ADDENDUM NO. ONE
NCSB -FBMS

To the Plans and Specifications for:
Nassau County School Board – Project No. 98110-031
Fernandina Beach Middle School Kitchen / Dining Remodeling and Campus
Renovations/Enhancements

Date: October 15, 2018

BUILDING 08
FIRE ALARM,
INTERCOM & PUBLIC
ADDRESS SYSTEMS

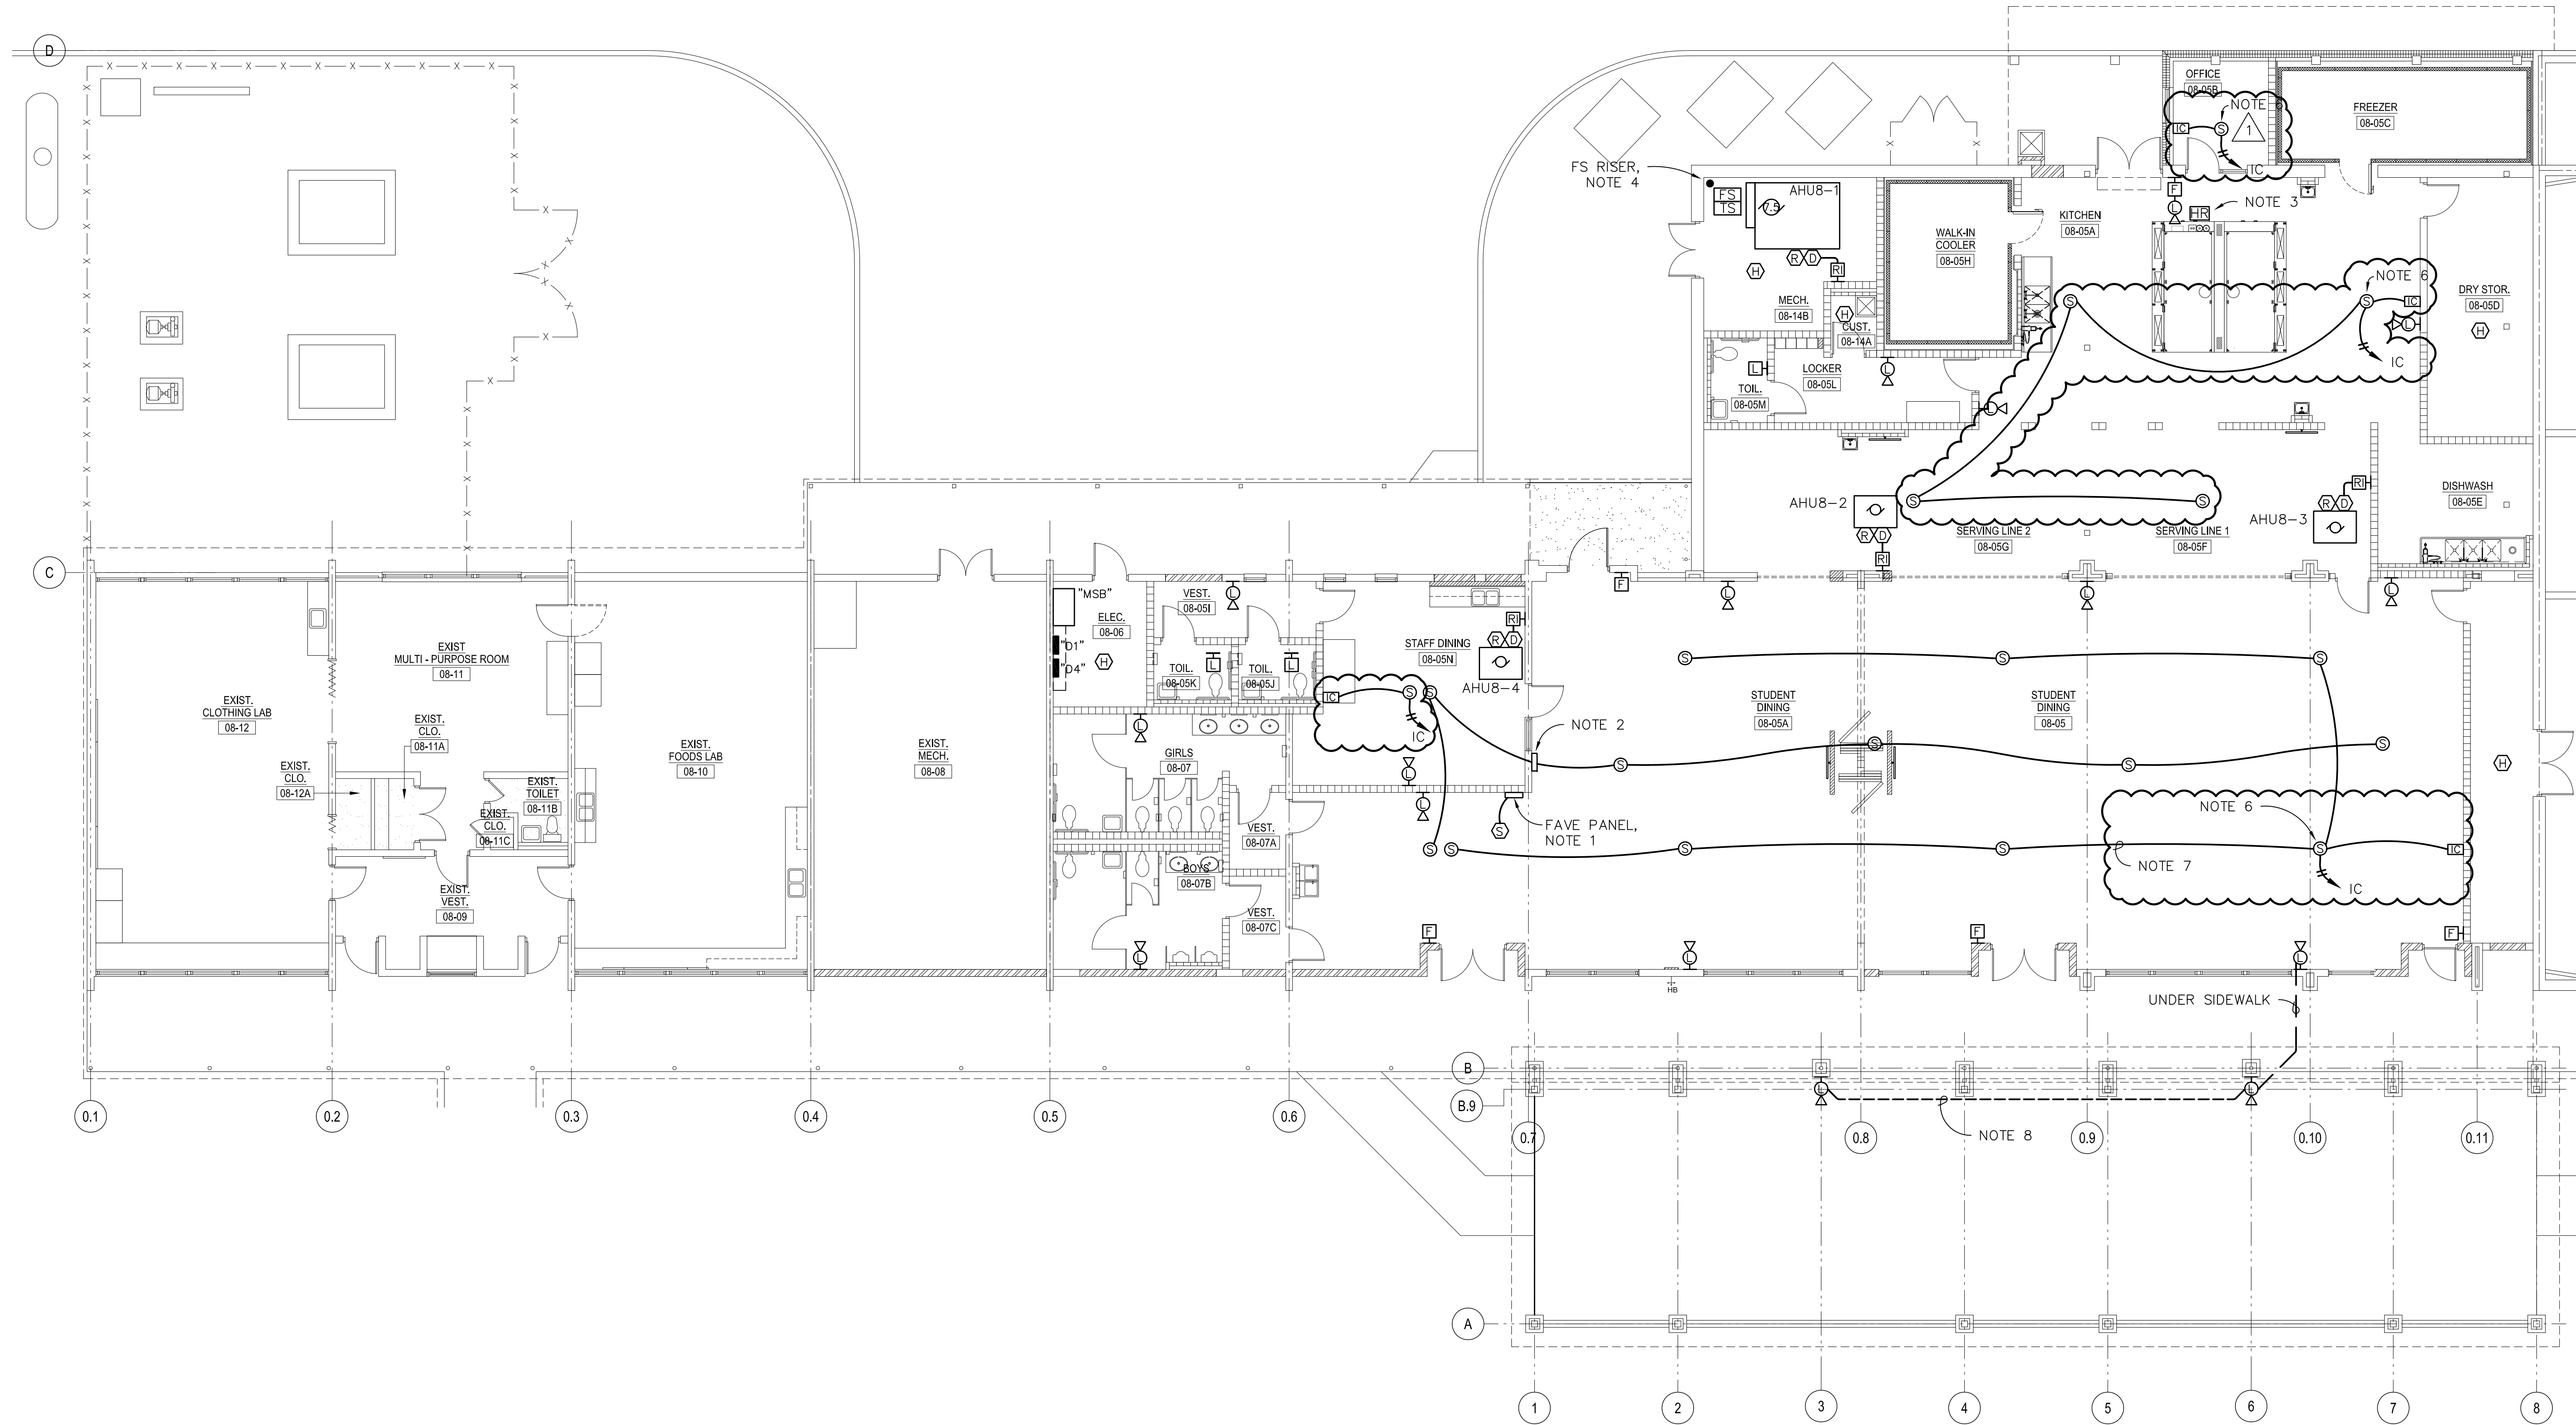
- a. Delete existing Drawing and insert attached new Drawing dated October 15, 2018.
- b. See additional intercom call buttons, speakers and wiring to Building 02 added.
- c. See revised Notes 6 and 7.

6. PROVIDE NEW INTERCOM CEILING SPEAKERS CONNECTED TO NEW WIRING FROM BUILDING 02 INTERCOM RACK.
7. PROVIDE NEW WIRING INSIDE BUILDING FOR ALL NEW SPEAKERS. INSTALL ALL INTERCOM WIRING IN CONDUIT.

BLDG. 08 SINGLE LINE DIAGRAM

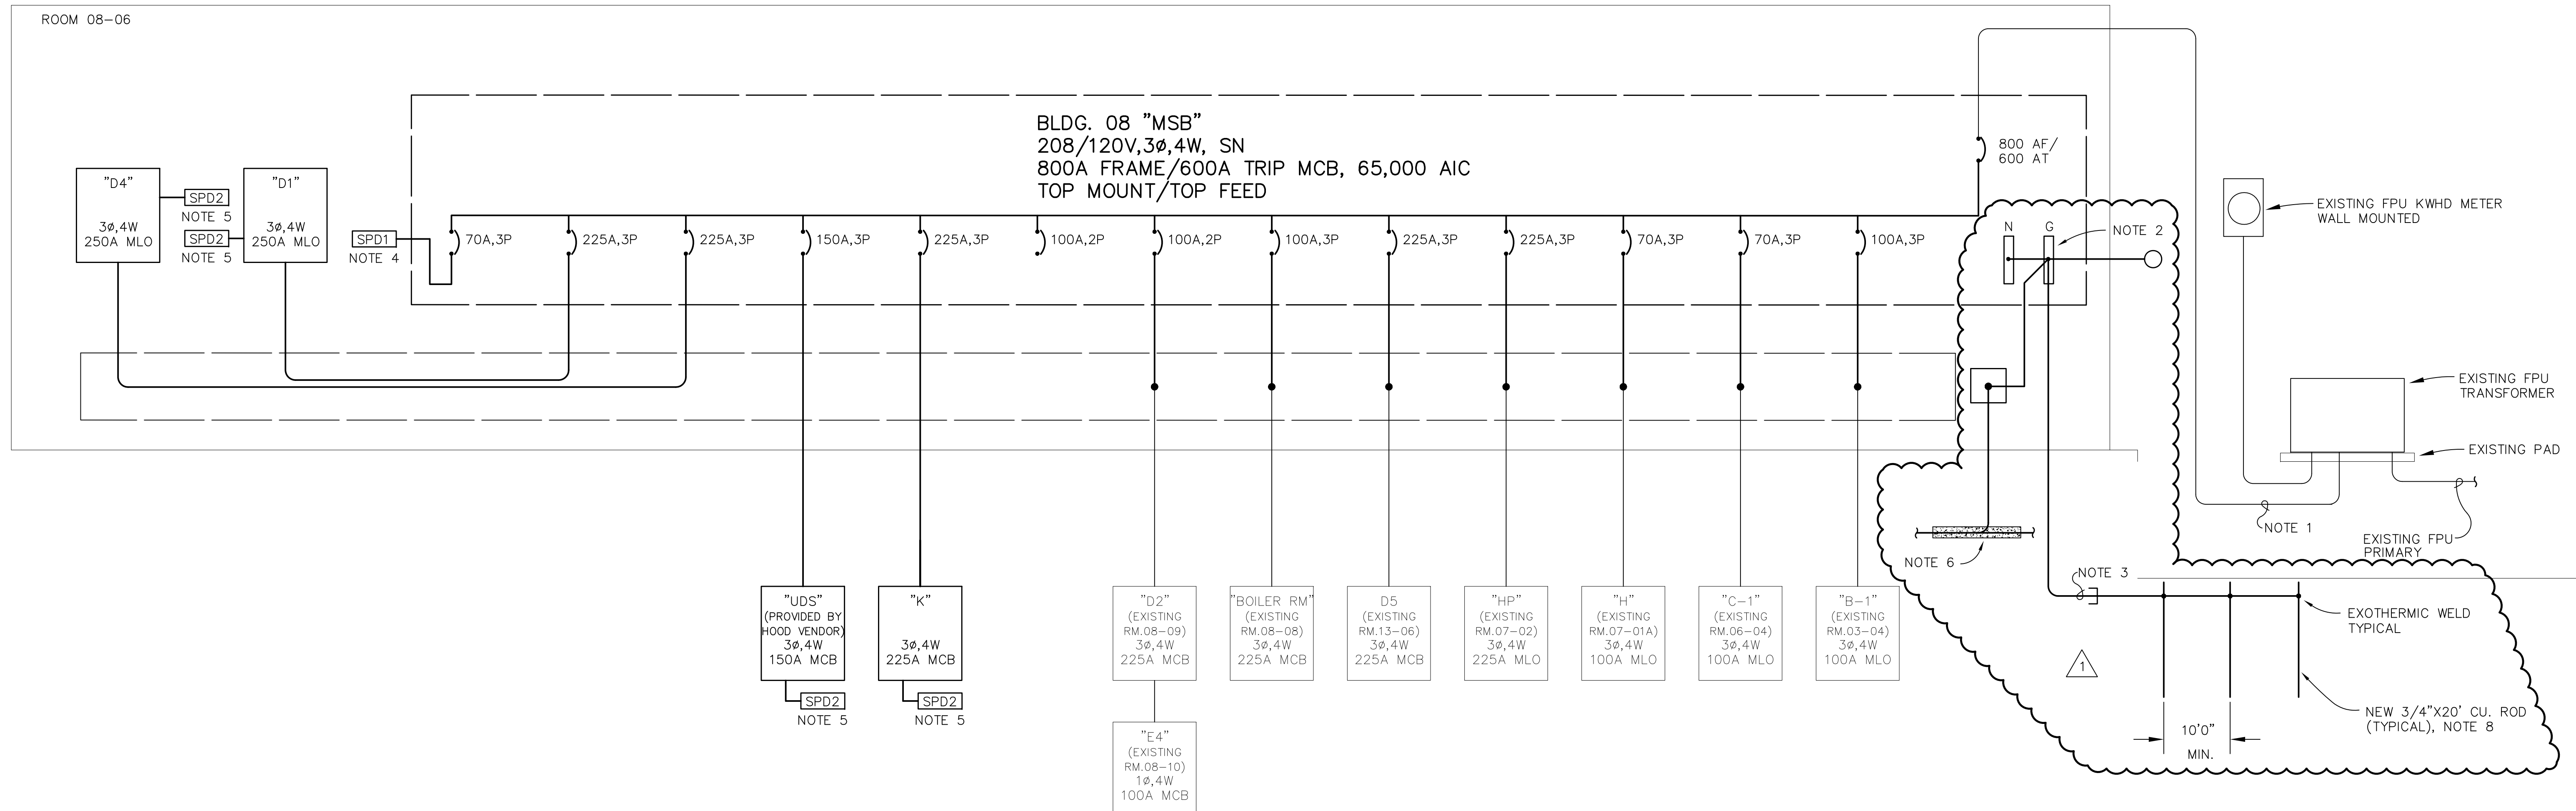
- a. Delete existing Drawing and insert attached new Drawing dated October 15, 2018.
- b. See revised grounding requirements on the single line diagram.
- c. See revised Notes.

- PROVIDE A #5X25' REBAR ENCASED IN THE NEW WALL CONCRETE FOOTER AND ADJACENT TO FOOTER REBAR. PROVIDE EXOTHERMIC WELDED CONNECTION INSIDE JUNCTION BOX ON INTERIOR WALL. PROVIDE #3/0 BARE COPPER GROUND CONDUCTOR TO "MSB" GROUND BAR.
